## REMEDIATION SYSTEM EVALUATION

### BAIRD AND MCGUIRE SUPERFUND SITE HOLBROOK, MASSACHUSETTS

Report of the Remediation System Evaluation,  
Site Visit Conducted at the Baird and McGuire Superfund Site  
April 18-19, 2001

Final Report Submitted to Region 1  
January 18, 2002

**FIGURE 1-1. SITE LAYOUT SHOWING THE LOCATIONS OF THE EXTRACTION WELLS (CURRENT AND RECOMMENDED) AND THE SVOC PLUME FROM THE 2000 SAMPLING EVENT.**

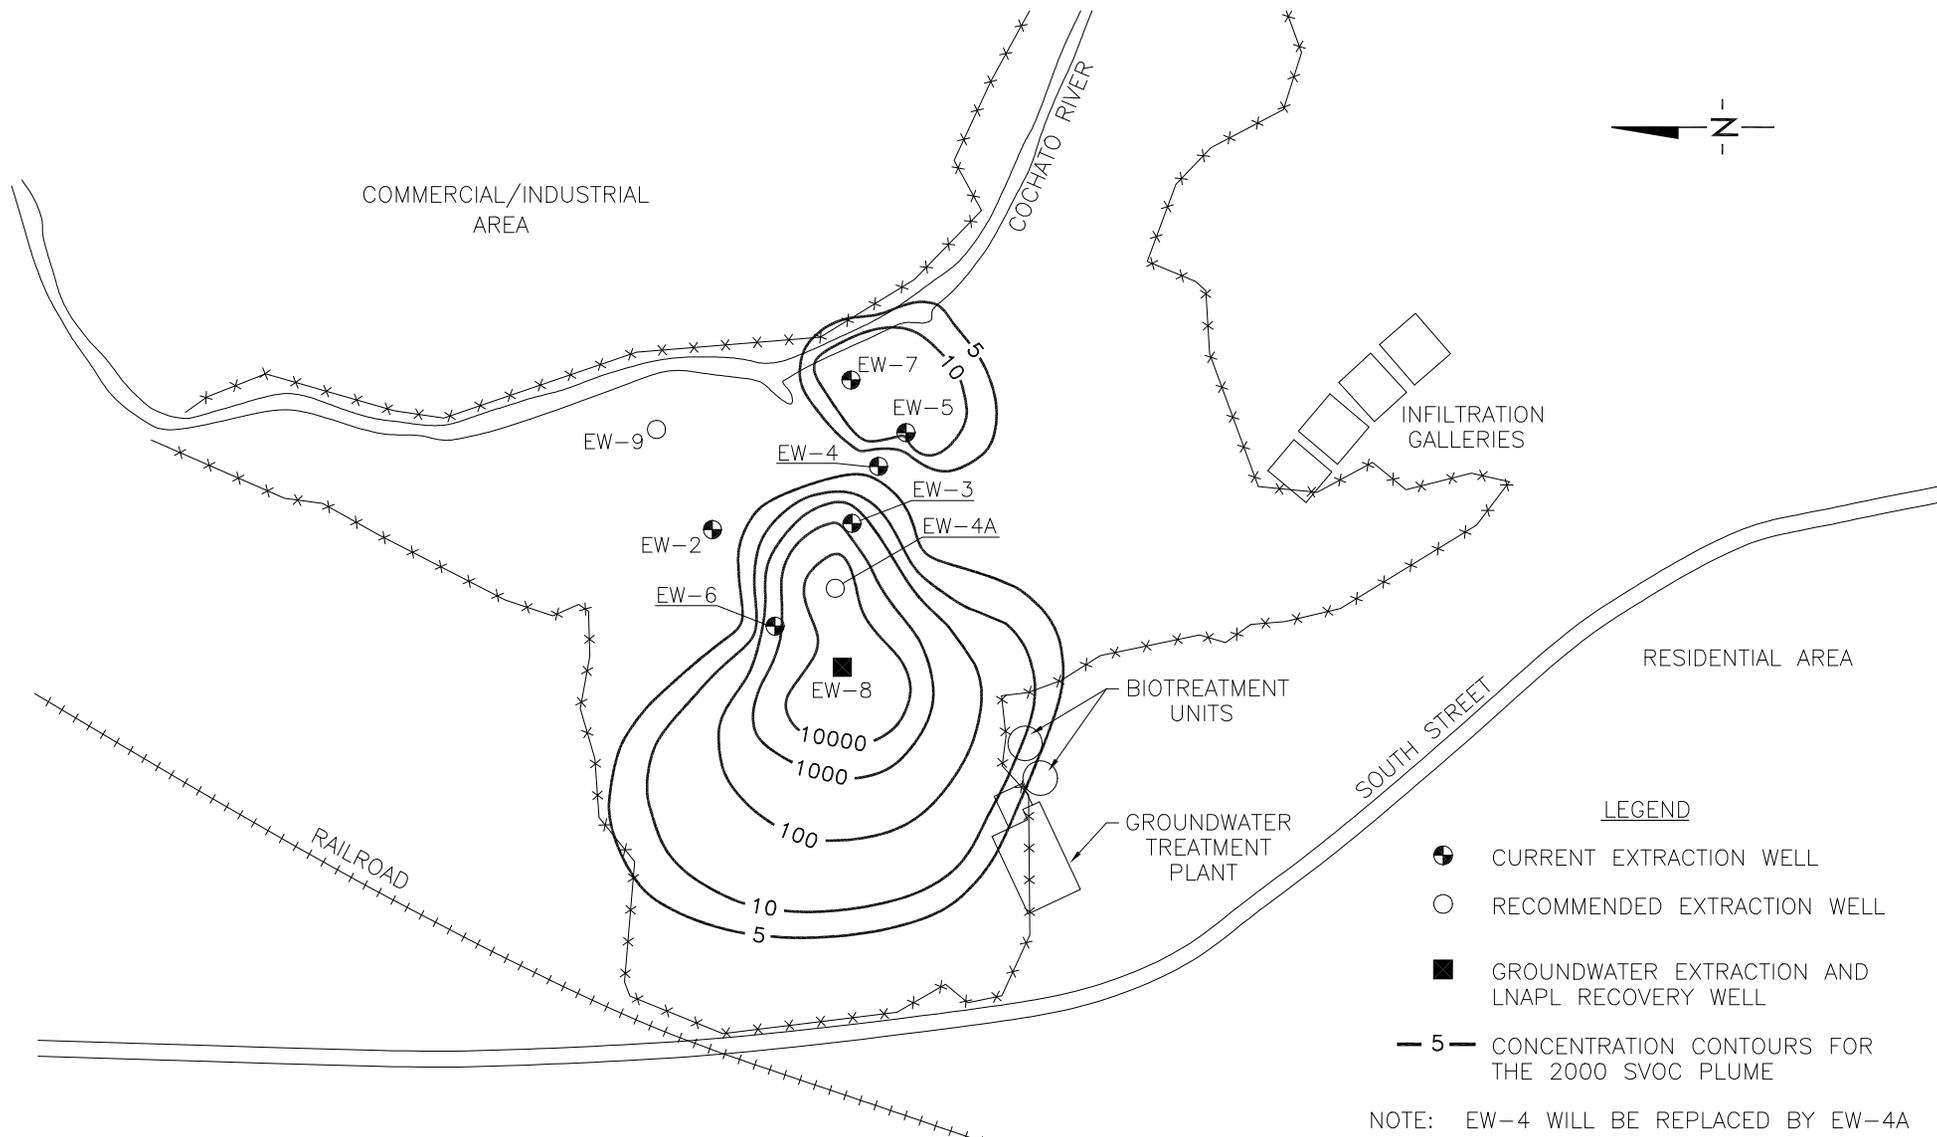
The remedy at the Baird and McGuire site appears to be effective, although at a much higher cost than is actually necessary. The modeling studies have demonstrated that the plume is contained and has been since the operation of EW-7 in 1998. Furthermore, effluent monitoring suggests that the treatment plants is effectively removing contaminants and discharging water that meets the required levels. The RSE team concurs with the previous recommendations of M&E (January, 2001) to change the location of EW-4 and install a new extraction well (EW-9).

FIGURE 2-1. CONCEPTUAL DIAGRAM OF THE GROUNDWATER TREATMENT SYSTEM

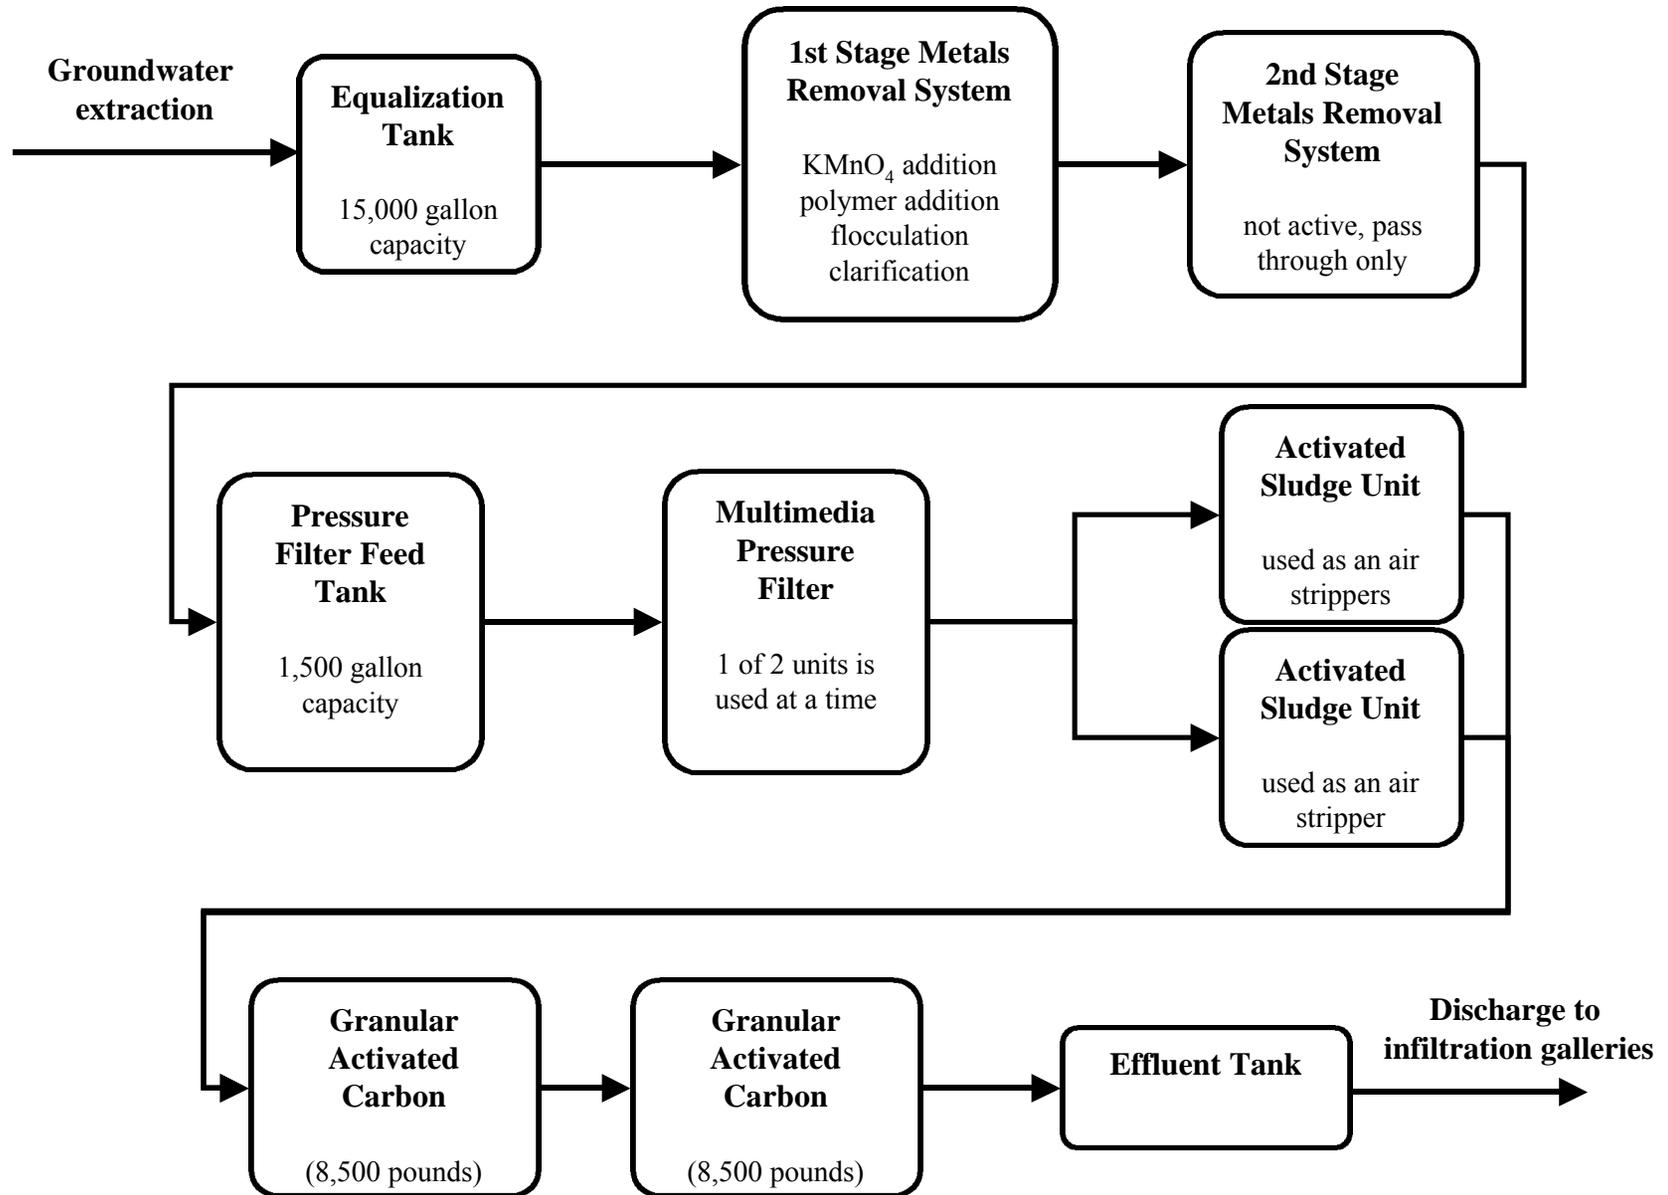
The two activated sludge units have not supported a bacterial population and have therefore been used only as air strippers. Two 20 horsepower blowers supply air to these two units, and overall mass reduction of organics is around 75%. Together, these blowers require approximately \$3,000 per month in electricity (assuming \$0.10/kwh).

A low profile tray aerator using a 7.5 horsepower blower could provide substantially higher mass removal at approximately \$500 per month in electricity (assuming \$0.10/kwh). Thus, a savings of approximately \$2,500 per month (or \$30,000 per year) could result from installing and operating a tray aerator in place of the current activated sludge units. The improved reduction in the mass of organics in the process water could also extend the time of the GAC units if the pressure filtration media is improved to prevent fouling. Purchase, installation, and start up of the tray aerator should require approximately \$400,000 in up front costs.

The system equalization tank is about 15,000 gallons. This provides only 90 minutes to make system repairs without having extraction-well downtime. As the 150,000-gallon aeration tanks are not needed in the treatment process, one could be converted to an emergency equalization tank if desired. This would provide approximately 900 minutes to make system repairs without having extraction-well downtime.
